Model: CPD-200ES**No.** 211**Subject:** No Picture; Loose CN309 Connector**Date:** July 27, 1998**Symptom:
(131X)**

RTV LOCATIONS

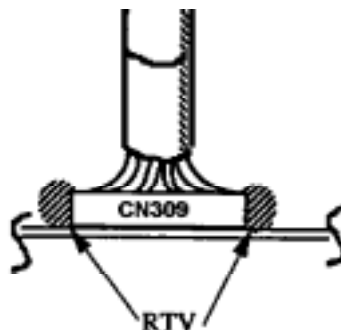
The unit has no picture. CN309 may become loose or separate from the mating connector on the A Board. CN309 is part of a signal cable connecting to CN511 on the D Board. Affected units have SN less than 4041717.

1. Inspect CN309 and the mating connector on the A Board and clean or align electrical signal contacts as necessary.
2. Insert CN309 into the mating connector on the A Board. Seat firmly in the mating connector.
3. Adjust the cable position between CN309 and the cable harness to minimize tension on CN309.
4. Apply RTV adhesive between CN309 and the mating connector on the D Board. Refer to the following illustration.
